APPLICATION NO.	FILING DATE	FIRST NAMED INVENTOR	ATTORNEY DOCKET NO.	CONFIRMATION NO.
10/674,622	09/30/2003	Stephen Friend	66205-0001	4195

## Office Action Summary

This is the second office action for application number 10/674,622, Bottle Retainer, filed on September 30, 2003.

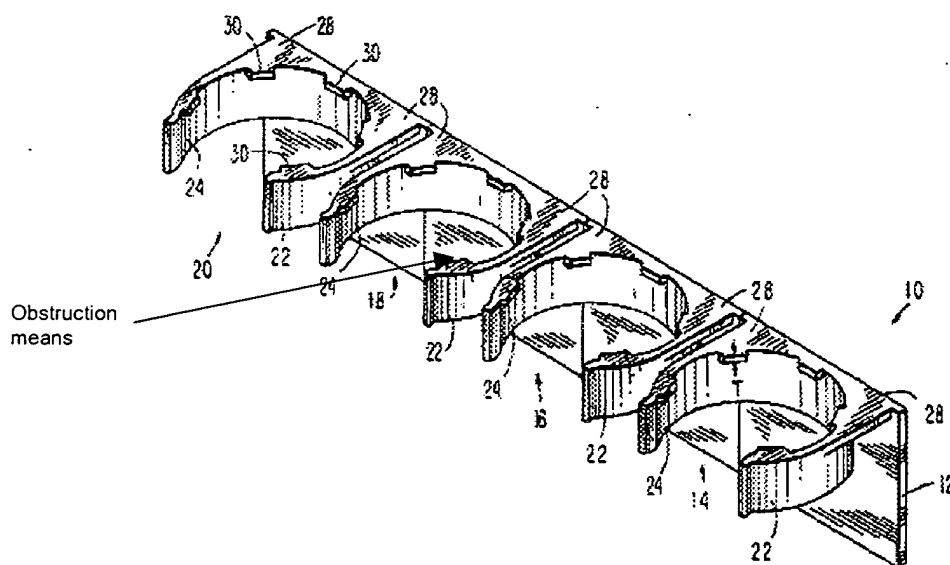
Claims 8-10 are rejected under 35 U.S.C. 102(b) as being anticipated by U.S. Patent number 5,655,673 to Weterrings et al.

Weterrings et al. '573 discloses a retainer (above) comprising an affixing means (12) adapted to mount the retainer to a surface, receiving means (14,16,18,20, generally) inherently adapted to slidably receive at least one bottle (a bottle or the like is inherently slid in between

the arms, also, see column 2, line 7), and obstruction means (above), wherein the receiving means further comprises bifurcated arms (22,24, above) wherein the arms an opening (between 22,24 above).

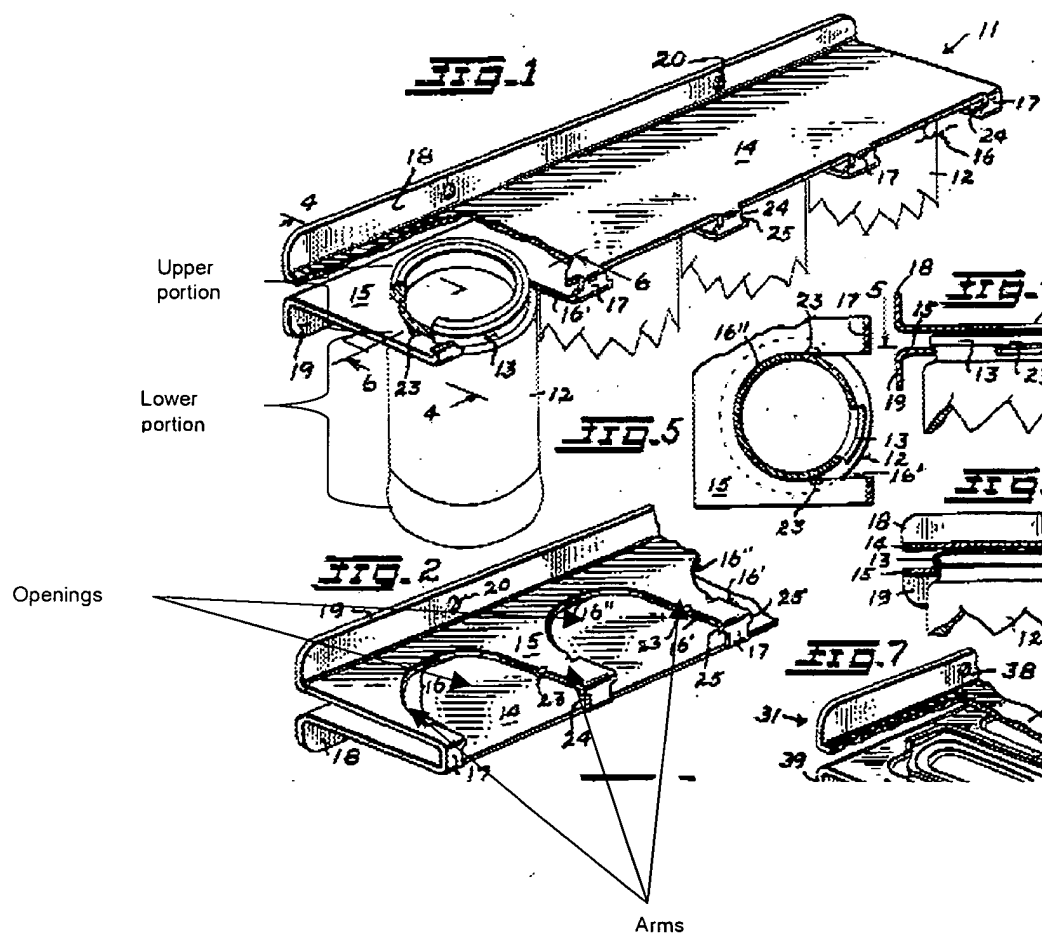
Claims 1, 2, 3, 5 and 7 are rejected under 35 U.S.C. 102(b) as being anticipated by U.S.

Patent number 2,921,690 to Smith et al.

Smith et al. '690 discloses a retainer (above) comprising a base having an affixing portion (19) and a retaining portion (15, generally), the affixing portion having a back side and a front side, the back side for mounting the retainer to a surface (column 2, lines 26-30), at least two generally horizontal, substantially parallel arms (above) extending from the base to form at least one unobstructed opening therebetween for slidably receiving the lower portion of a bottle (see above) with the upper portion of the bottle engaged by the arms to support the bottle within the at least opening, wherein the retaining portion further comprises at least three of the (above) that form at least two unobstructed openings inherently for slidably receiving bottles therein, wherein each of the arms has at least one raised obstruction (23) positioned on an upper portion of the arm to resist accidental bottle engagement, wherein the affixing portion is further inherently adapted to receive at least one fastener for mounting (through portion 20) the retainer to a surface, wherein the at least two openings are equivalent in size.
